**RESOLUTION SCHEDULING HEARING ON THE ISSUANCE OF  
A CERTIFICATE OF APPROPRIATENESS FOR EXTERIOR ALTERATIONS  
TO THE AMERICAN FEDERAL BUILDING**

**1. Request from Diocese of Des Moines (owner) represented by Jason Kurth (Co-Chancellor) to allow the following at 601 Grand Avenue (American Federal Building). (20-2017-4.01)**

## Site and Building Rehabilitation / West Wall Infill

Catholic Pastoral Center  
601 Grand Avenue, Des Moines, Iowa

Existing Conditions

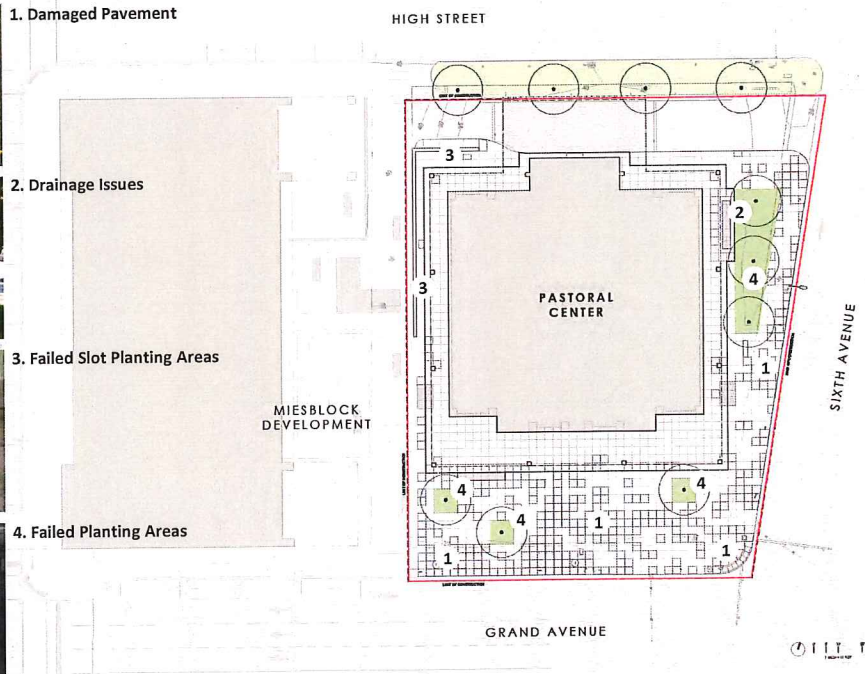
- Hielkema: Consider interconnection of the two sites with uplighting and interplay between the sites.
- Weisenbach: The Miesblock development has incorporated some stormwater infiltration components in the planting areas. Is there a way for that to be mimicked in a way that meets the historic guidelines?

In response to Ms. Weisnebach's question, Mr. Holt stated that other than addressing a small area of ponding issues related to damaged intake drains, there is no requirement to provide additional stormwater management on the site. The design team will make an effort to create a relationship between the planting materials of both sites.

### Landscape Plan

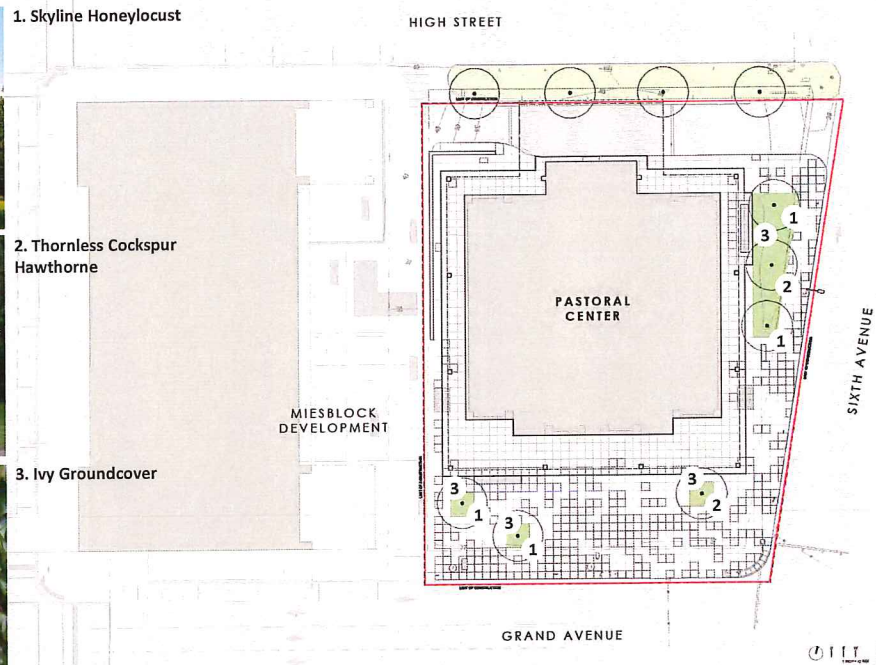
- Reynolds: Encourage exploration of a larger caliper tree to fill the 10' planting beds and evergreen ground cover options.
- Hielkema: Glad to see the trees in front are being replaced.

Trees on the south side of the site will be replaced although trees at the north of the site are healthy and will remain. Replacement trees will be 1 ½" inch caliper. The design team is exploring drought tolerate ground cover options that hits the original monoculture design intent.

### Proposed Sculpture

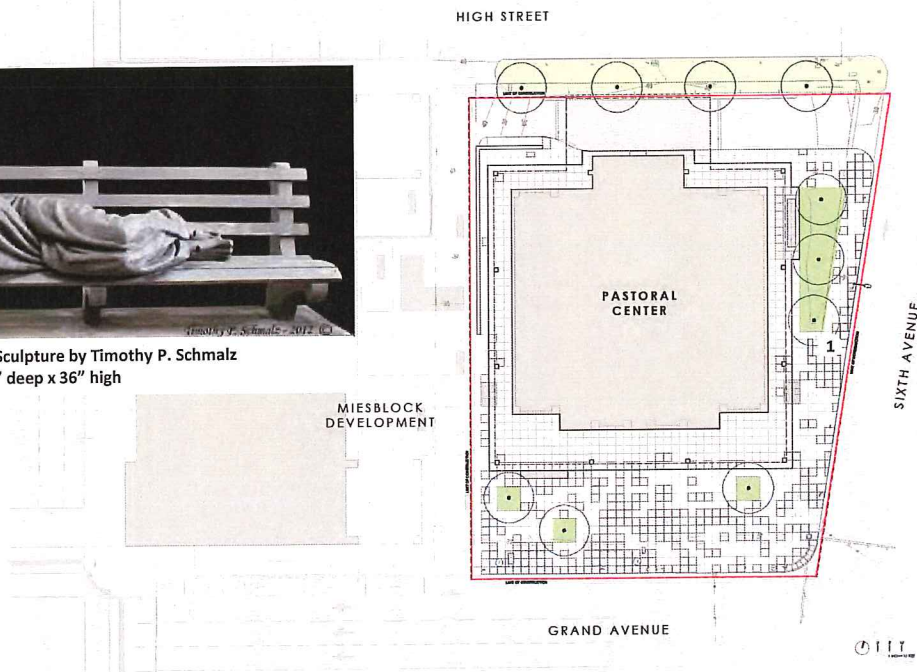
- Reynolds: Feel that the sculpture works appropriately in the proposed location. May explore integrating it into the planter just to the north so that it becomes a part of the landscape as opposed to part of the plaza.

Staff requests that the Landmark Review Board recommend approval of the requested Certificate of Appropriateness subject to approval of the proposed sculpture by the Community Development Director or his designee following consultation with the State Historic Preservation Office of Iowa.
